SIB 11 11 21

RECALL 21V-907: EXHAUST GAS RECIRCULATION (EGR) COOLER – N47T LOW TEMPERATURE

This Service Information Bulletin (Revision 3) replaces SI B11 11 21 **dated October 2022**.

PROCEDURE 1: REPLACE THE EGR COOLER

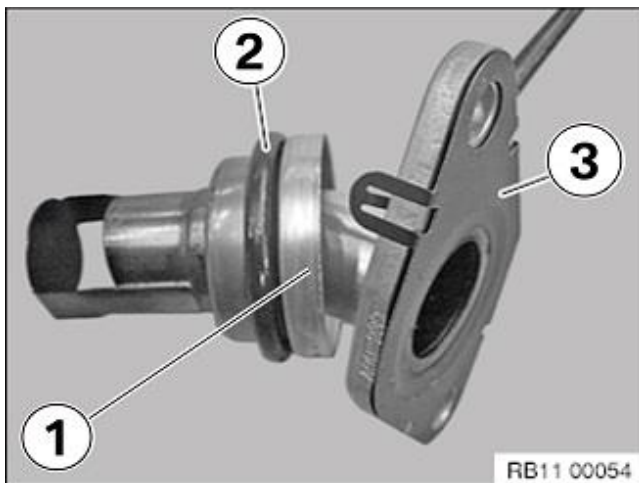
- When the old EGR cooler is removed:

- Remove the EGR pipe from the intake venturi pipe (replace O-ring (2) and gasket (3)).

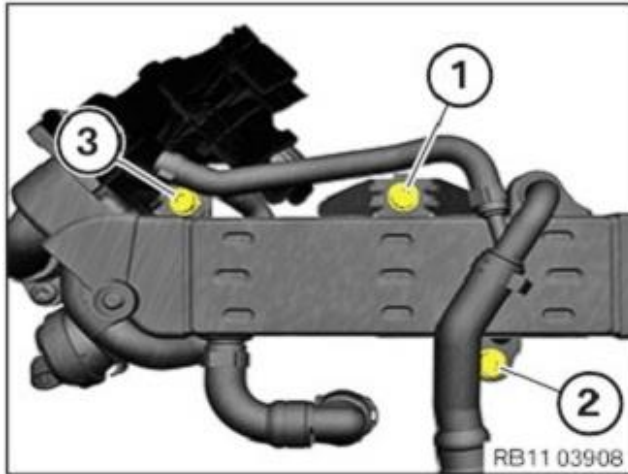
- Inspect and clean (if needed) the EGR pipe. Wear protective equipment (eyes and hands) and clean out the excessive carbon using a degreasing agent and a brush (suitable brushes can be found in wheel brush kit 83 19 2 298 237).
- Reinstall the EGR pipe with new gasket and O-ring before installing the new EGR cooler.
- Install the new EGR cooler following the repair instructions.
- Replace the coolant line with temperature sensor 11 53 7 827 841

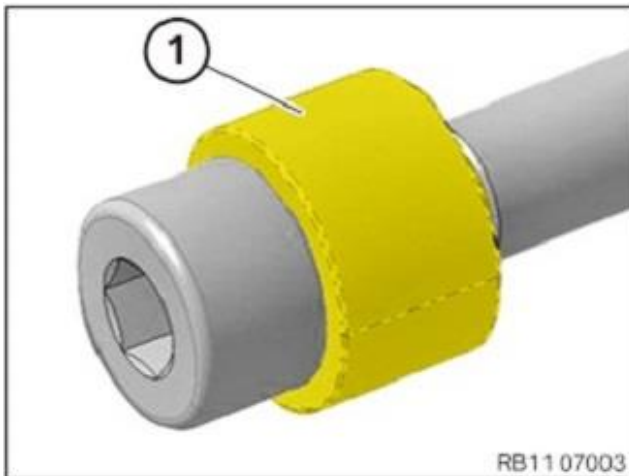
- Inspect highlighted screws before reusing.

- Replace the screws if they do not have the 10mm spacer (1). Use PN 07 14 9 886 429 (included in parts kit 11 71 8 490 650).

- Replace the vacuum hose PN 11 65 8 595 650 (enough hose for two repairs) from the changeover valve to the bypass flap on the cooler (measure the new hose and cut according to the old hose)
- The acoustic cover will be replaced with PN 11 14 8 490 570 (if an acoustic covered was installed)
